IMMINGHAM EASTERN RO-RO TERMINAL

Applicant's Issue Specific Hearing 3 Action Points for Deadline 5 – Appendix 2 - DTA
Report 23325-27 including Annexes A-C

Document 10.2.45.2

Modelling Update and Sensitivity Test Note

Figure 1 – Summary of East Gate Survey

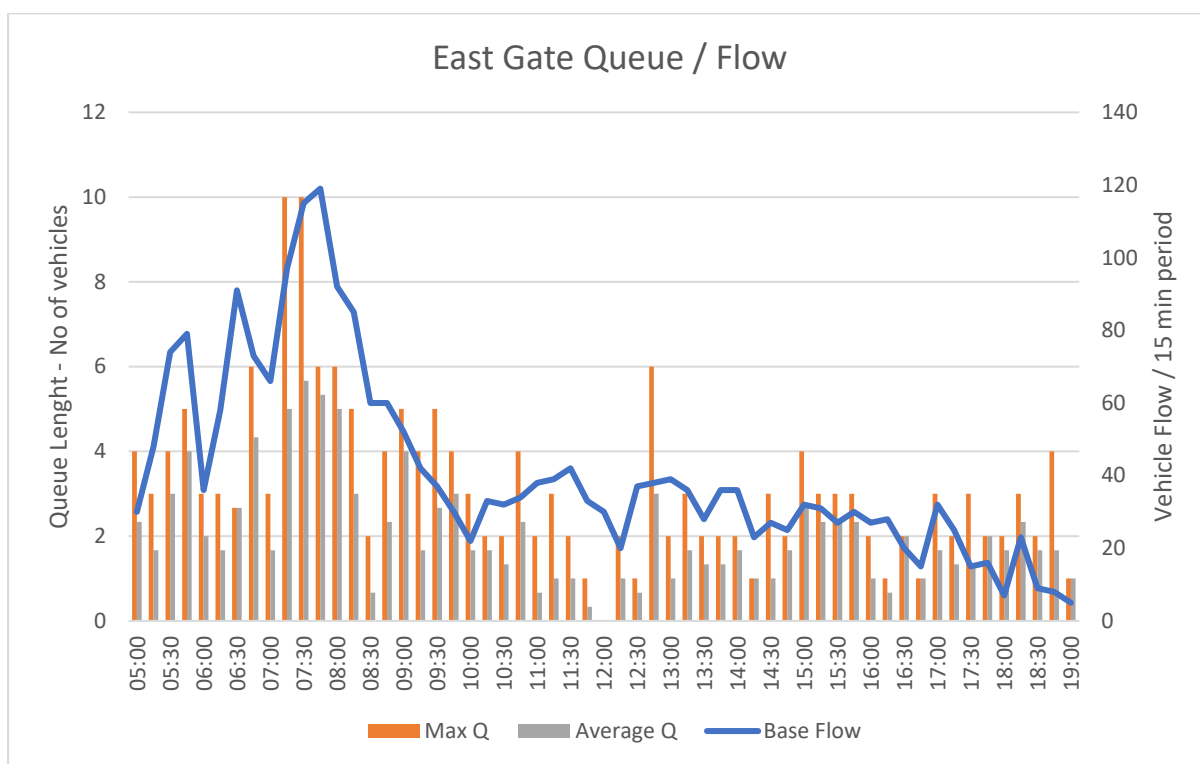
2.5 **Figure 1** below summarise the data in terms of inbound movements per 15-minute period and maximum observed queues for East Gate derived from the data provided at **Appendix A**.

2.6 It can be seen from the survey that, with the exception of some outliers, queue lengths generally correlated well with overall inbound flows. At present queuing at the gate is typically around 1 – 3 vehicles, with an average in any 5-minute period of 2 vehicles. At peak times (which is typically the morning period between 07:00 and 09:00 queues extended to around 10 vehicles but only for a short period of time. This is generally the time when peak movements occur because of inbound staff movements to the various operations on the port.

2.7 REP2-052 Figure 3 shows a queue of around 5 vehicles at East Gate at 07:10am. Again, this broadly correlates with the results in the applicants survey.

2.8 Whilst these queues will occasionally extend back past the right turn lane providing access to Laporte Road, the overall level of traffic on Queens Road which is not accessing the port (and therefore turning right into Laporte Road) is very low.

Figure 2 – Summary of West Gate Survey

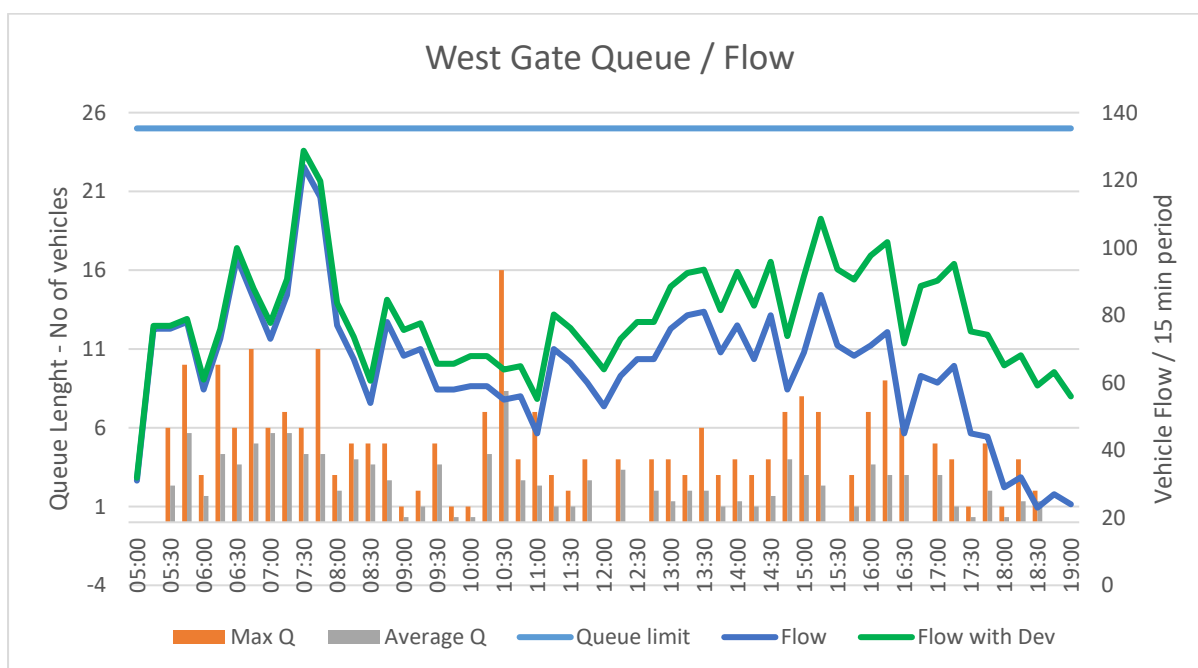
2.9 **Figure 2** shows the same data for West Gate again derived from the data at **Appendix A**. The Figure also shows the maximum queue length of 25 HGVs as defined below.

2.10 The survey at West Gate shows a similar pattern. Total vehicle flow (of upto 120 vehicles (over a 15-minute period)) are consistent with East Gate but result in higher queues generally as a result of higher levels of HGVS (around 60% of all vehicles at West Gate vs around 10 – 15% at East Gate).

2.11 There was one outlier event at 10:30 when a maximum queue of 16 vehicles was recorded). This quickly dispersed (to 8 vehicles in the following five minutes and then to 4 in the next 5-minute period.

- 2.12 REP2-052 also noted (Para 2.1) in relation to West Gate that “the queues occasionally back up to the Humber Road Junction as shown in Figure 1. It is worth noting that those occurrences are infrequent, and queues generally dispersed in two to four minutes.”
- 2.13 In practise although presented as “queues” in this assessment the majority of these incidents are more akin to slow moving lines of traffic rather than stationary queues one might experience at a red light, for example.

Figure 3 – East Gate Queues with IERRT HGVS (100%)

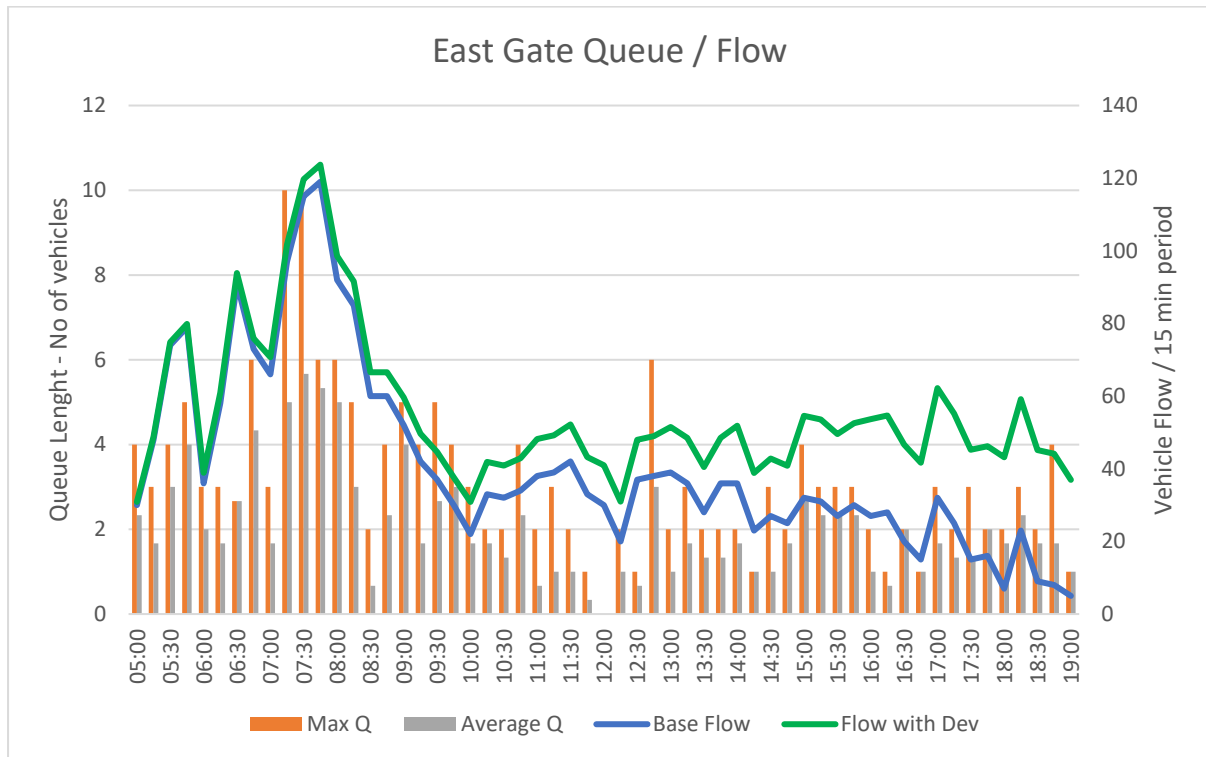
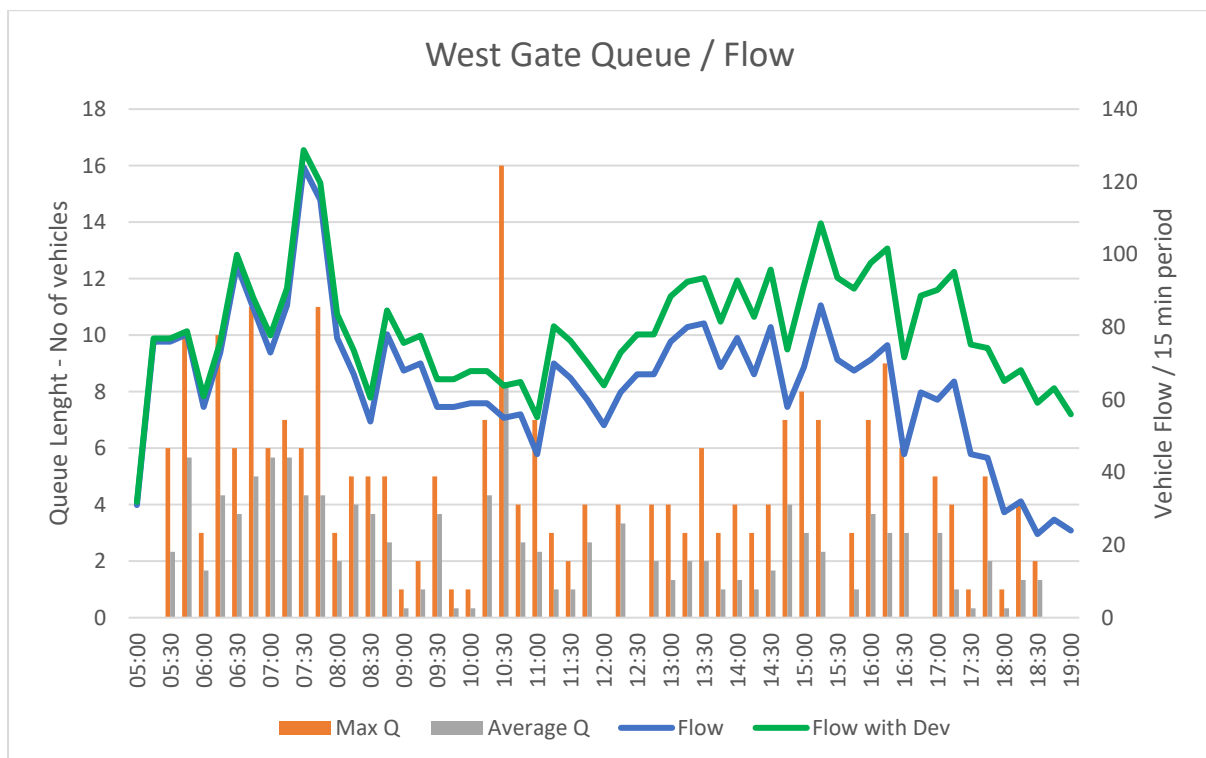
3.2 It can be seen from the above that the peak inbound demand from IEERT is generally in the afternoon period when peak demand will remain well below that experienced in the morning periods.

- 5.3 Based on **Figure 4**, and on the very robust assumption that 100% of inbound HGVs would use West Gate the overall profile of flows would flatten to the point that afternoon inbound flows would be similar to those experienced in the morning peak periods. On that basis it can be expected that the average queues of 5 – 6 vehicles and peak queues 10 – 11 vehicles in the morning period (05:30 – 09:00) will also be experienced in the afternoon period (from say 13:00 – 18:00).

Figure 5 – Google Earth Image – East Gate / Laporte Road Junction

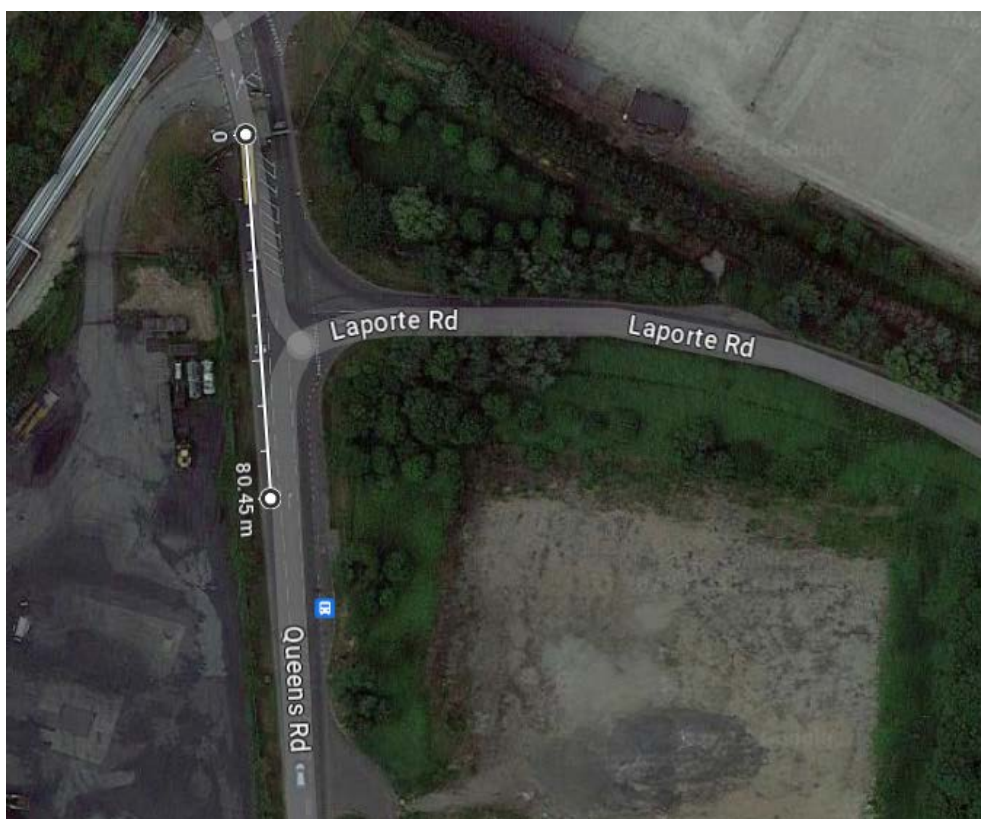
4.1 At present there is space for around 80m of queuing (broadly) at East Gate before the queue interrupts the ability for vehicles to turn right onto Laporte Road as shown below in **Figure 5**.

4.2 The survey of existing movements at Laporte Road / Queens Road (Page 1426 of AS-008 - Transport Assessment) confirms during the peak inbound hours for IERTT (across the afternoon) hourly movements of less than 30 vehicles per hour undertake this movement. Right turning movements from Laporte Road into East Gate are higher (around 60 movements per hour) and this leads to occasional short-term queuing (around 8 incidents per day as shown on Page 1427 of AS-008) – likely a direct result of the queue caused by the security gate.

4.3 There is no record of any personal injury accidents at this location in the last five years. and therefore, the situation is operating safely at present.
